This Service Information bulletin supersedes S.I. 72 04 96 dated April 1996 which should be removed and discarded from your S.I. binder.

SUBJECT: Fault Codes 16/17 or 24/25 in SRS Control Module

MODEL: 3 Series (E36), 5 Series (E34, E39), 7 Series (E38), 8 Series (E31)

Part manufactured after 04.04 1997

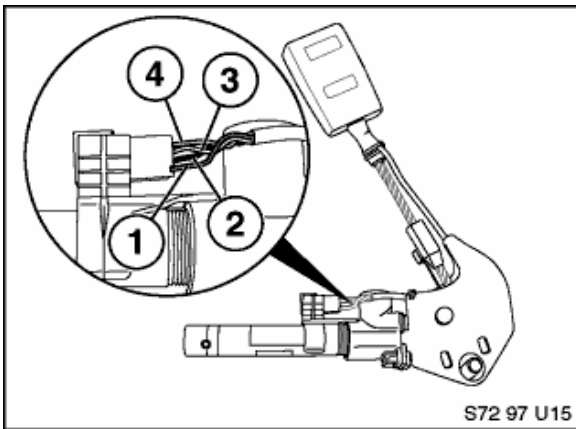
Correction: In order to rectify those problems, various improvements to the microswitch were implemented, with the most recent ones in:

- January '97- gold plated 100 Ohm contacts
- April '97- gold plated both contacts of the switch, 100/400 Ohm).

The safety belt latch with the latest improvements to the mechanical microswitch can be identified by the date **04.04.1997** or higher, stamped on the receptacle housing.

Four wires on the safety belt buckle side=Hall Effect Sensor.

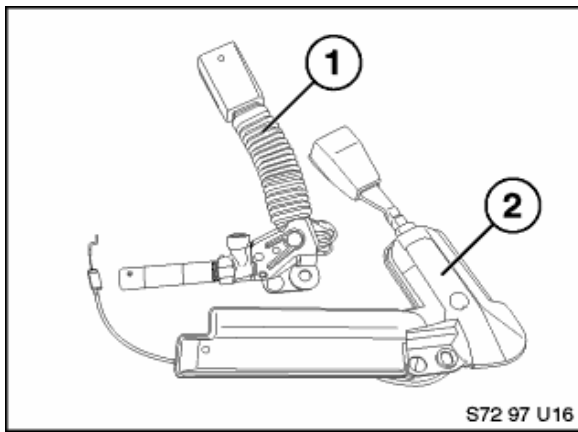
Furthermore, BMW has introduced a Hall Effect sensor replacing the mechanical microswitch. This production change took place in:

- June '97 for E36/2 (318is, 328is, 318ic, 328ic)
- July '97 for E36/4/5 (318i, 328i, 318ti)
- September '97 for E38, E39
- November '97 for Z3

The improved parts can be recognized in all models by the 4 pin, 4 wire connector (additional red wire supplies power to the Hall Effect sensor).

In 3/97 the vehicle harness of all models but the Z3 was modified providing a 4 pin connector on the vehicle harness side of the seat buckle connection. This was done in preparation for the introduction of the Hall sensor which requires a 4 pin connection. The Z3 had a 4 pin connector on the vehicle harness side from the beginning of US production.

Along with this harness change, safety belt buckles with new part numbers were introduced around 3/97; these modified safety buckles had a 4 pin connector, however, only 3 pins were present in those 4 pin connectors prior to the introduction of Hall sensor buckles.
